Opal St Clair

Response to letter 19th November 2021

17th June 2022

Screens and Battens

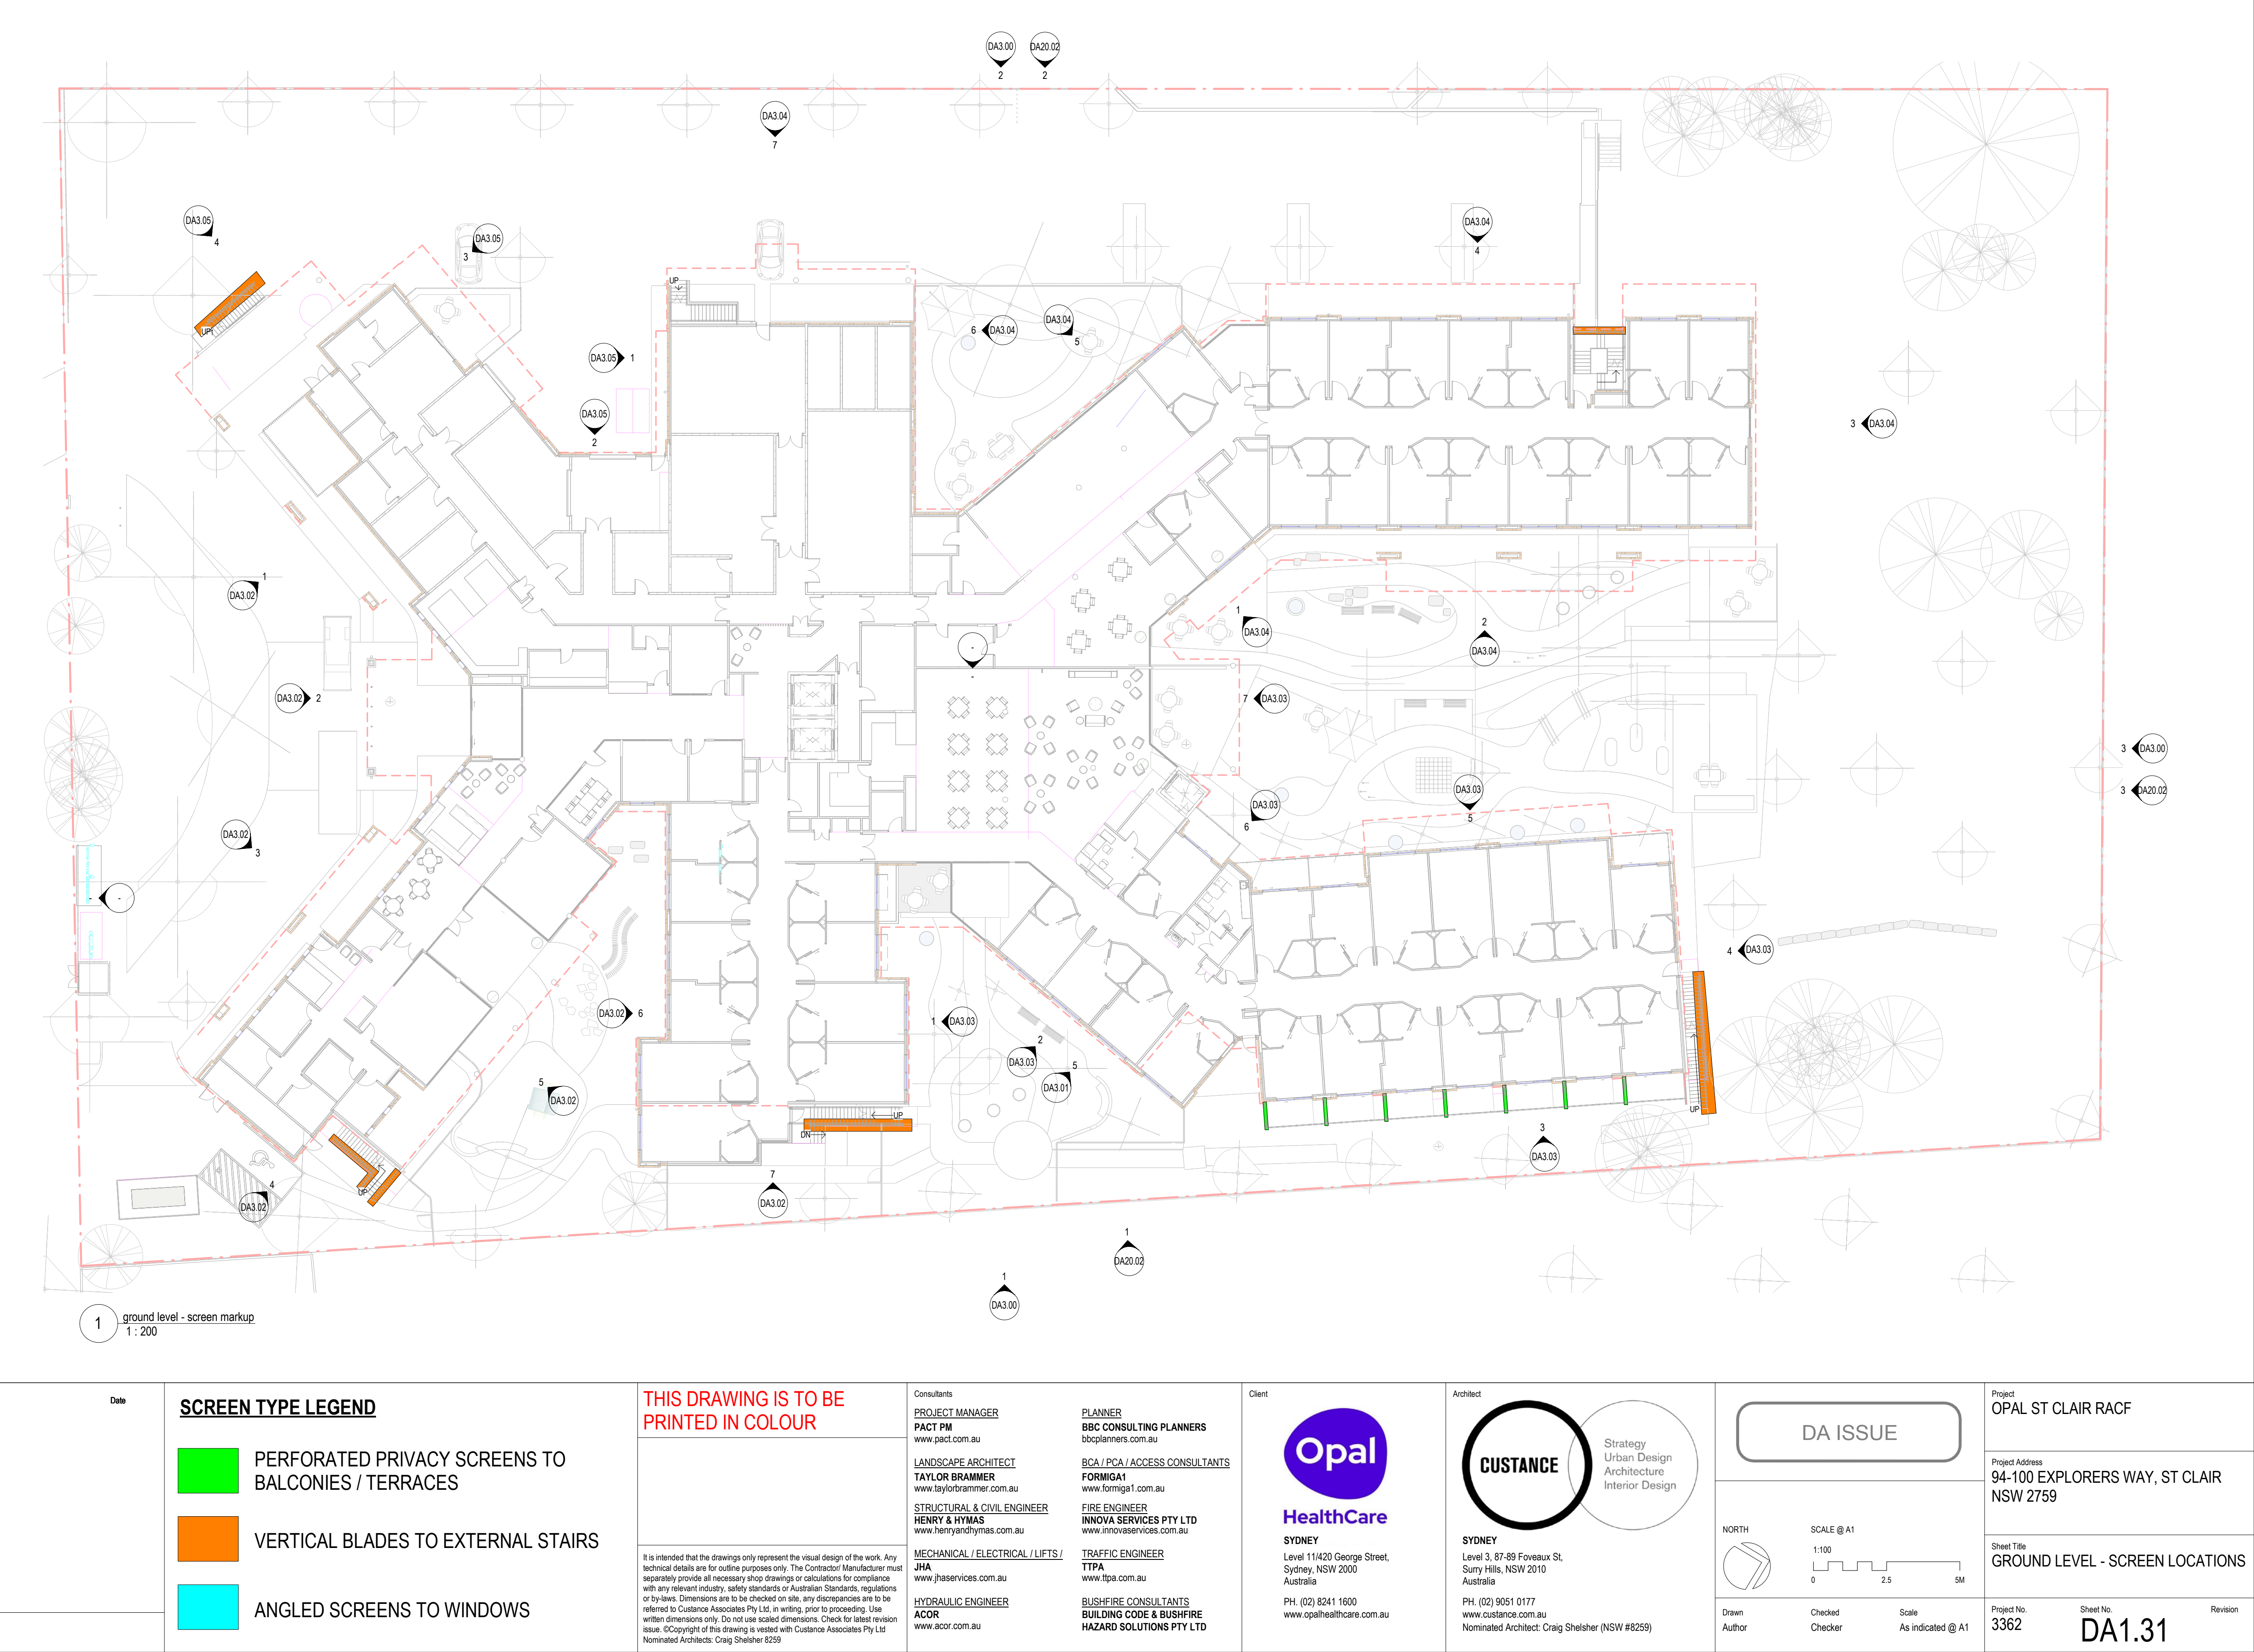
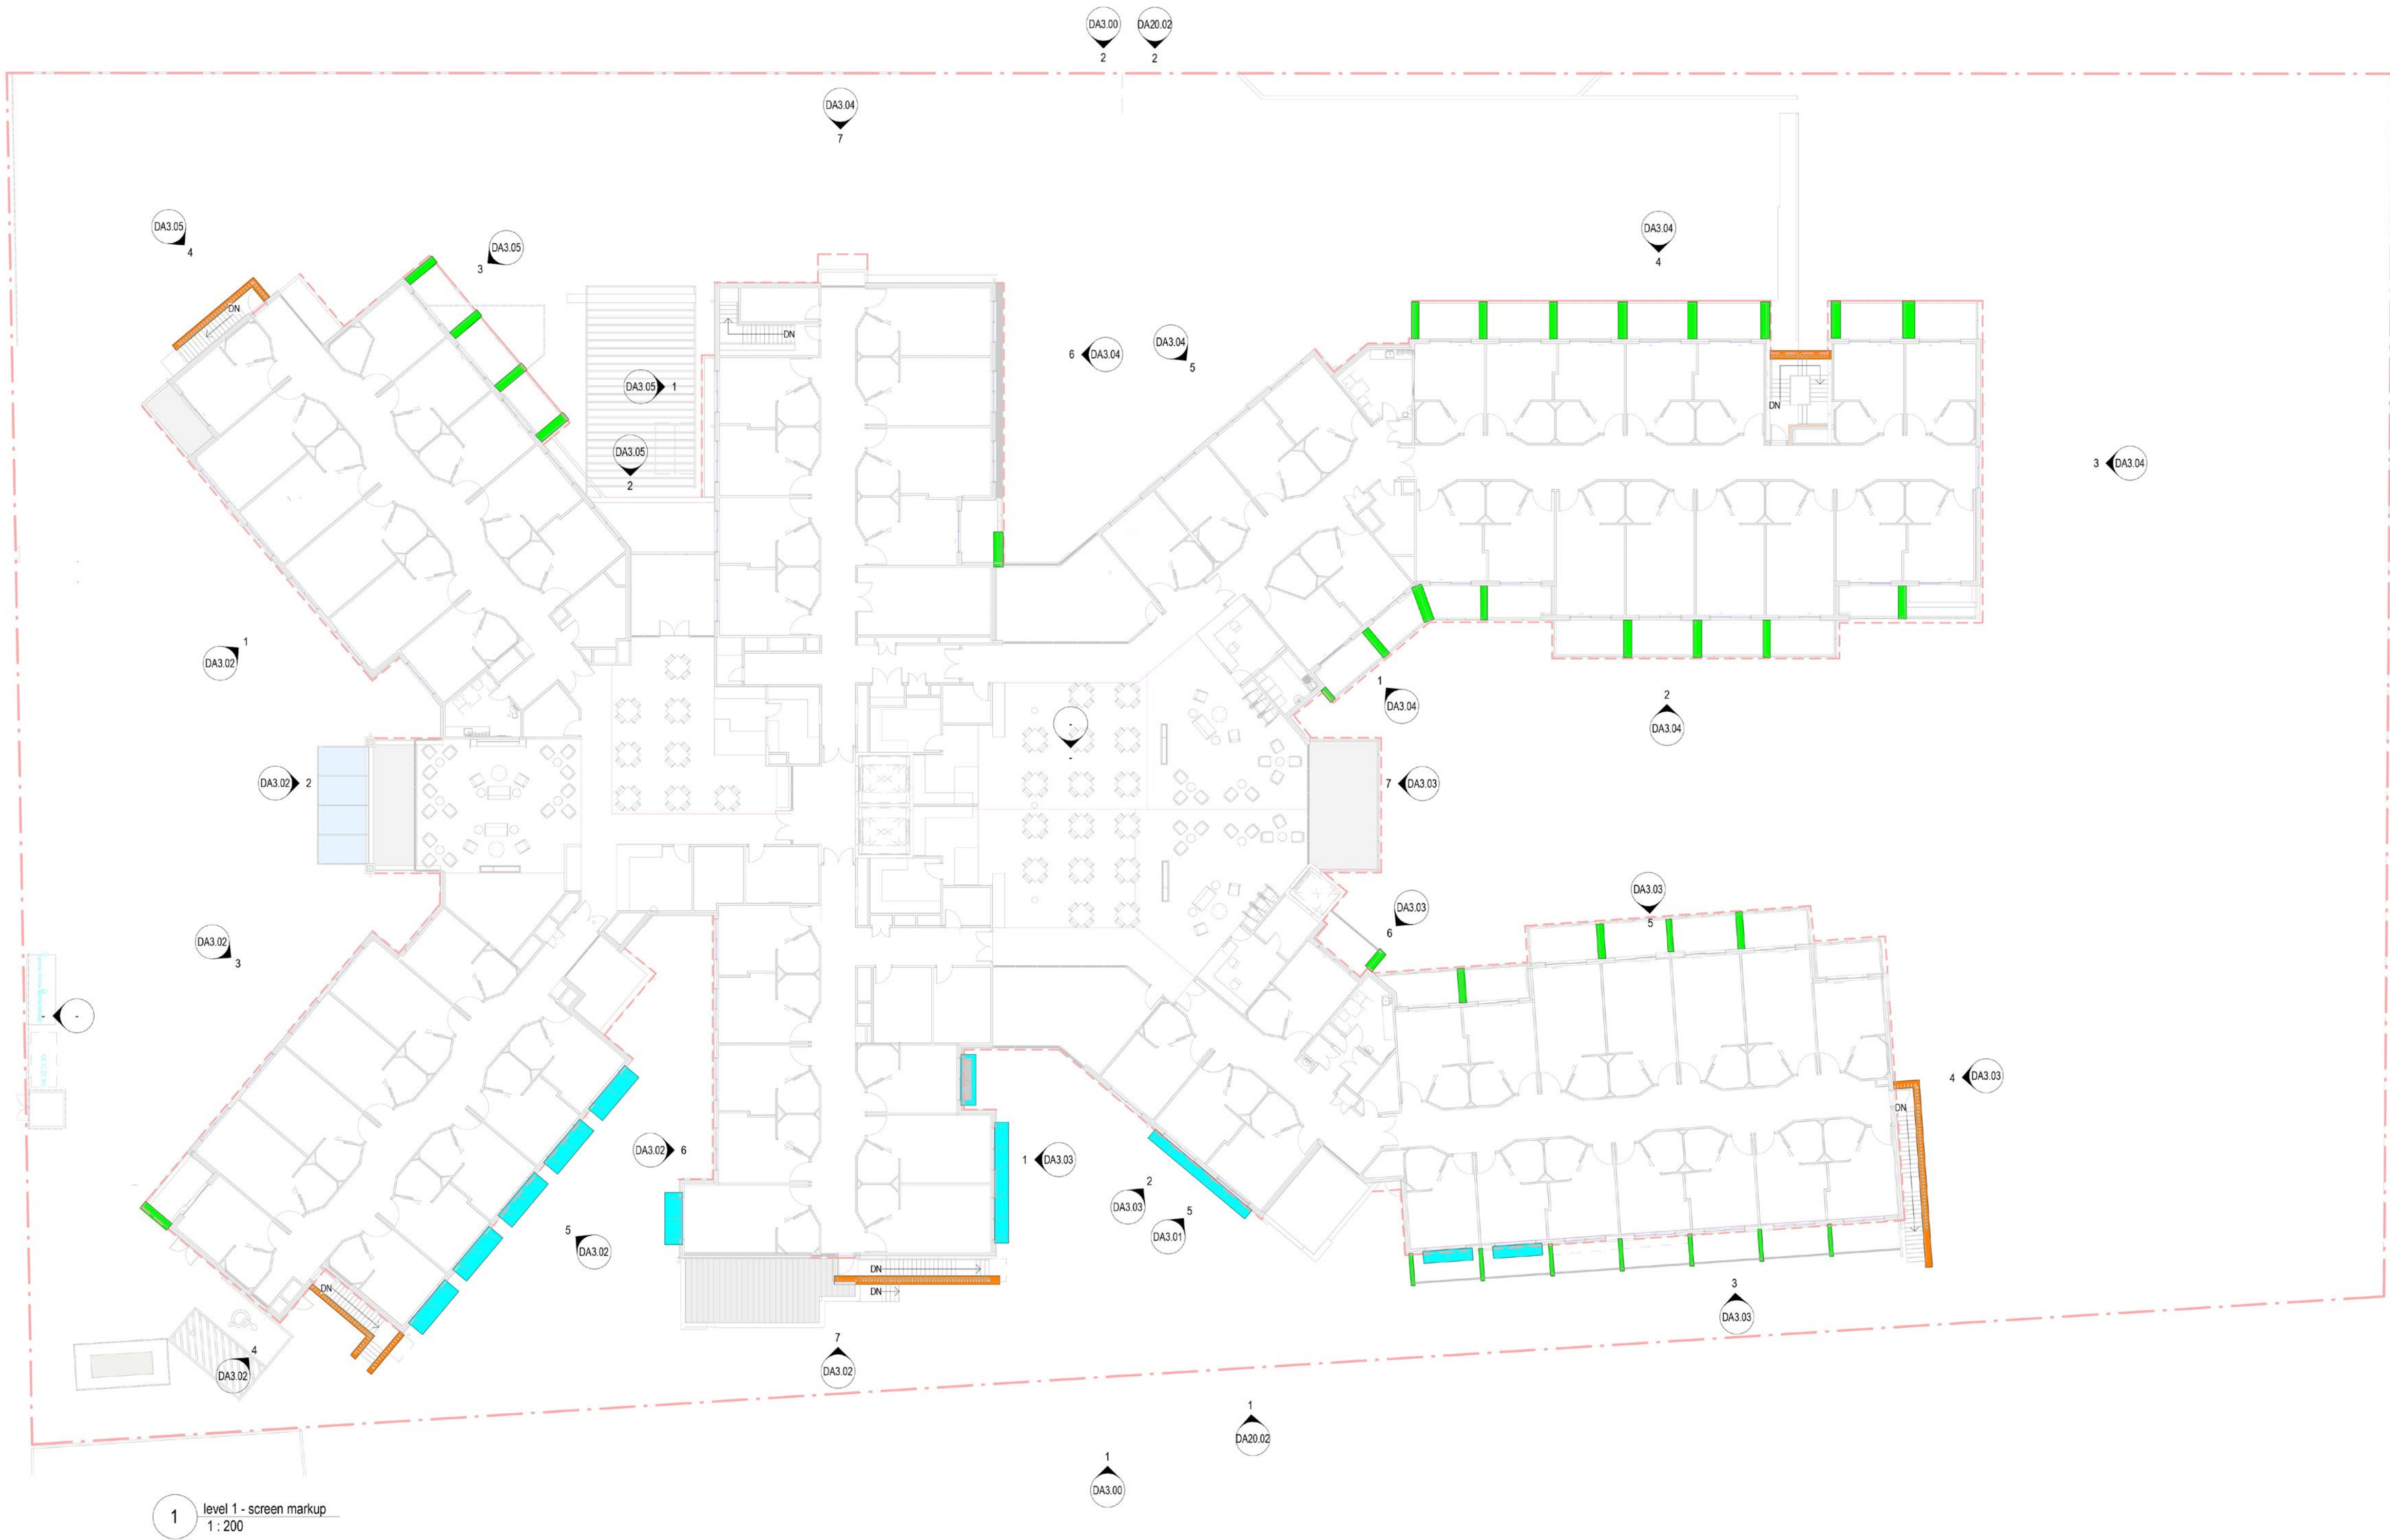
ITEM 12 – Concerned raised

FENCING KEY

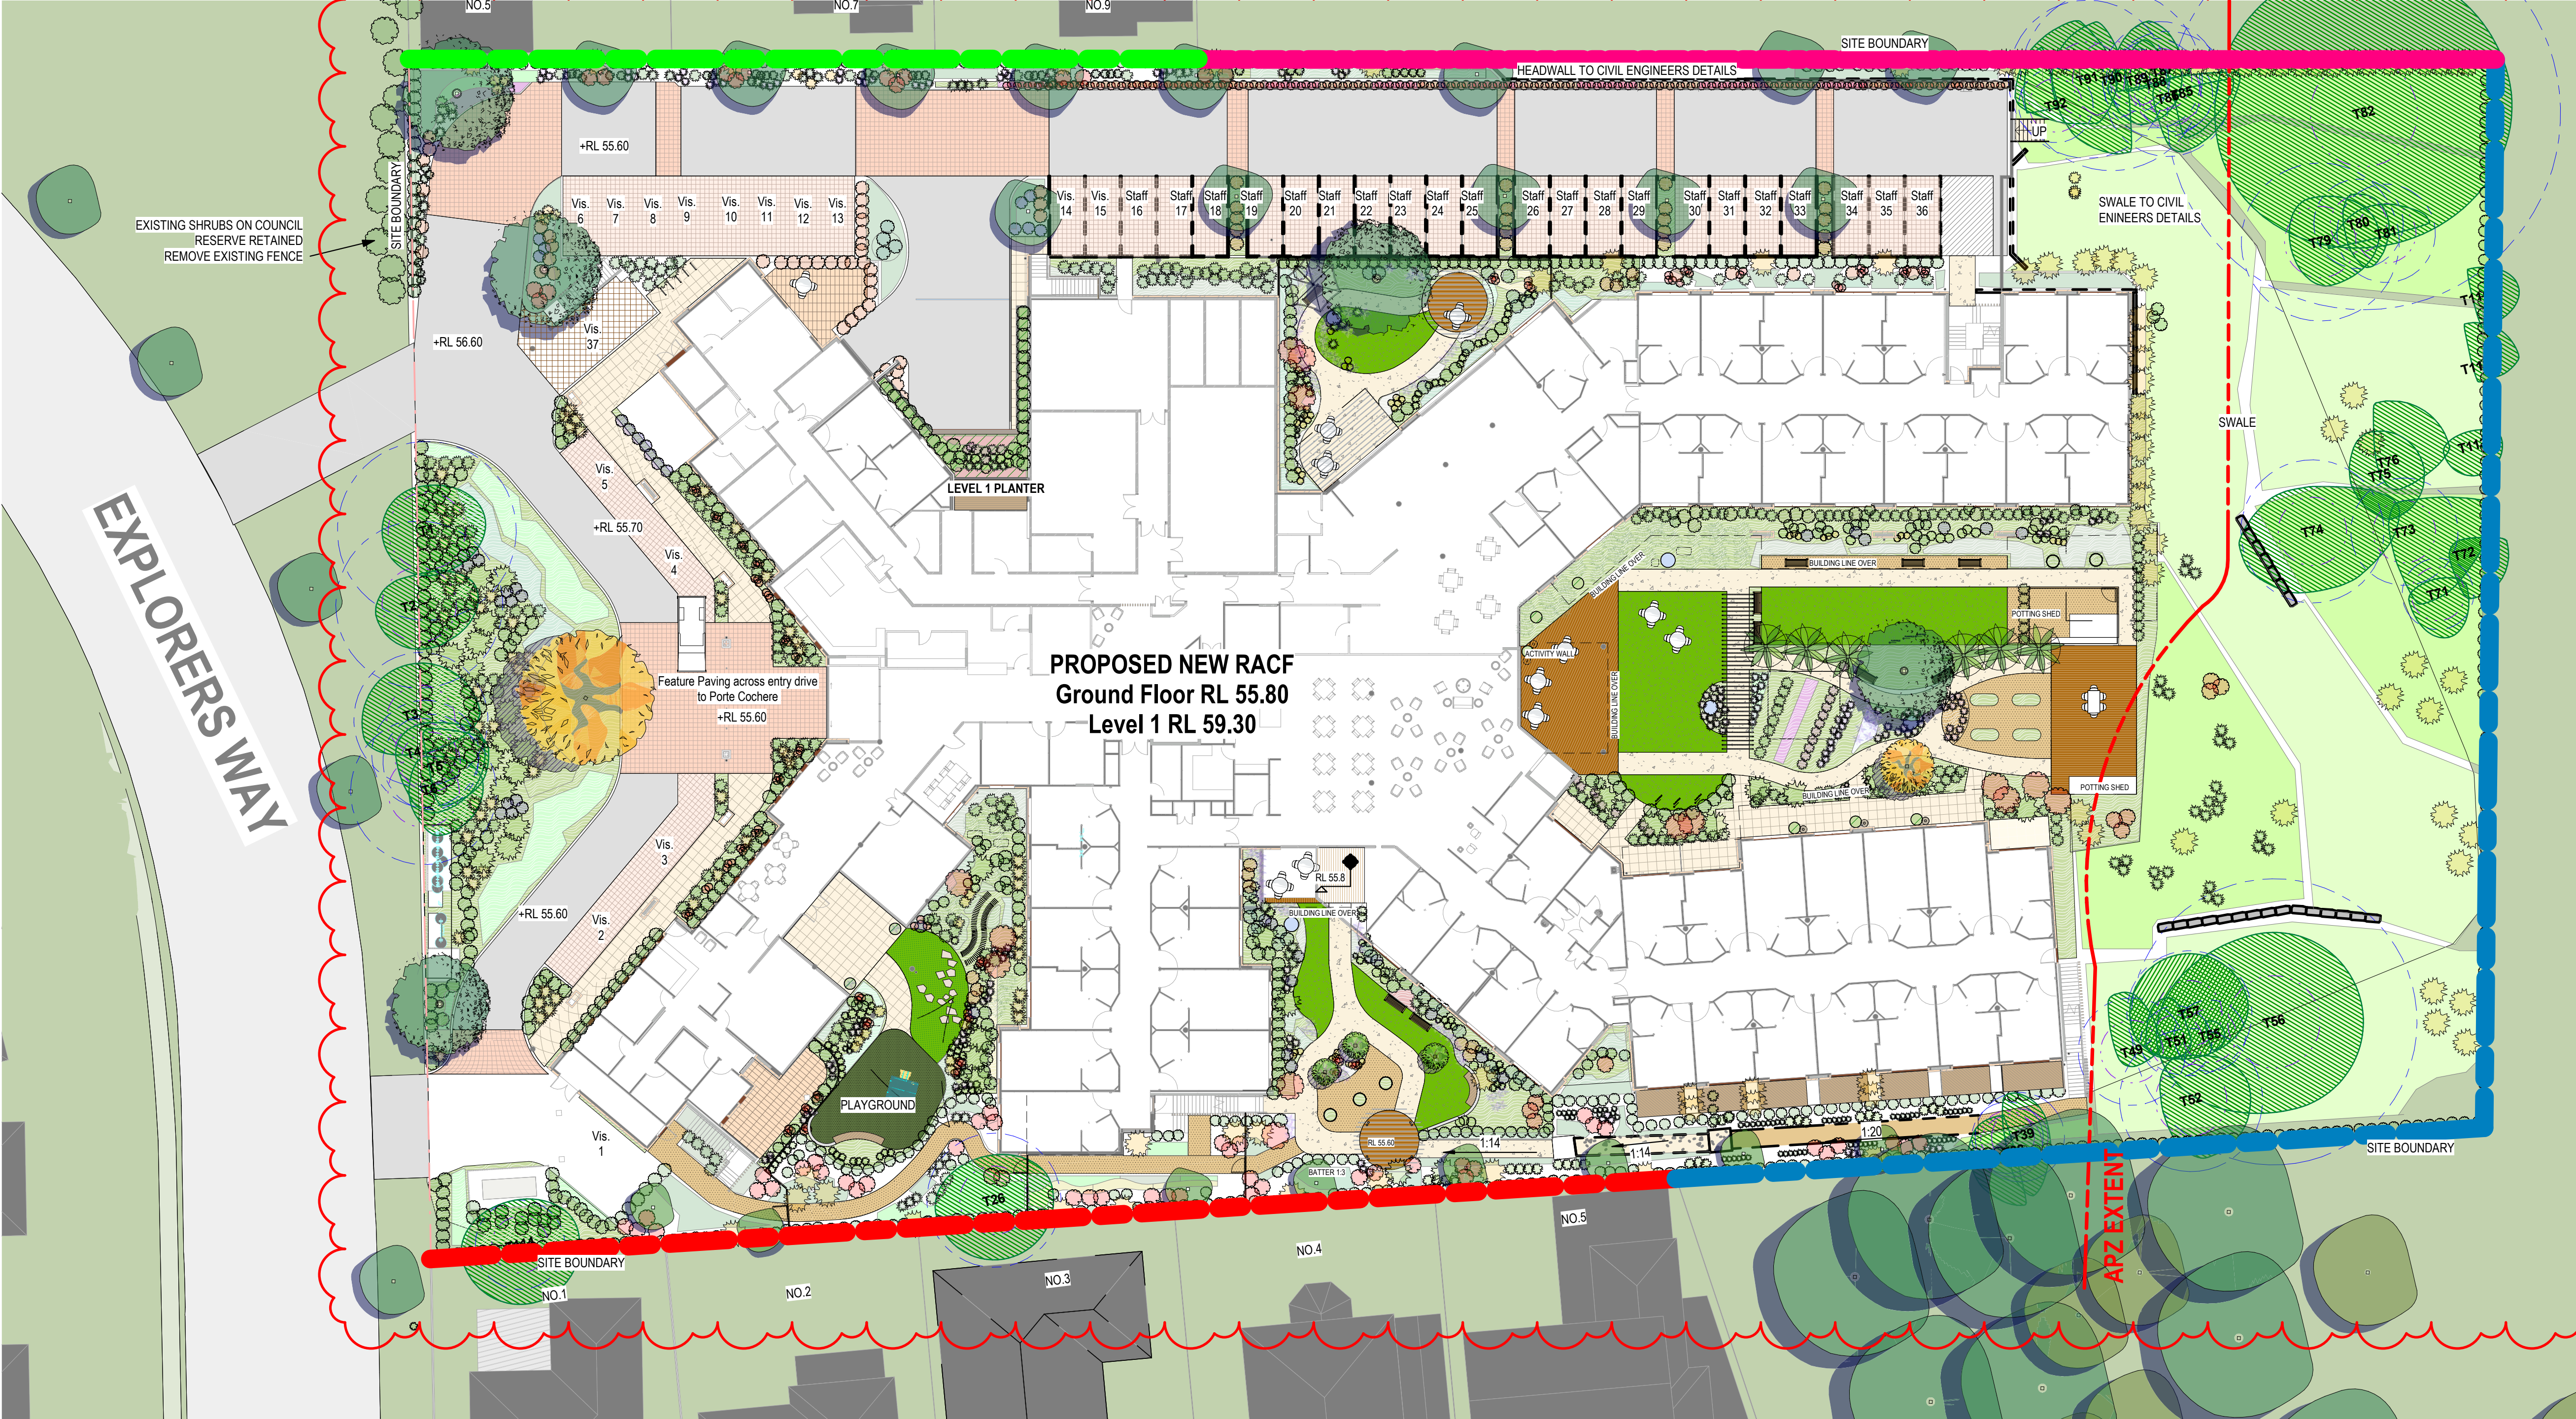
Fencing plan required

See diagram:
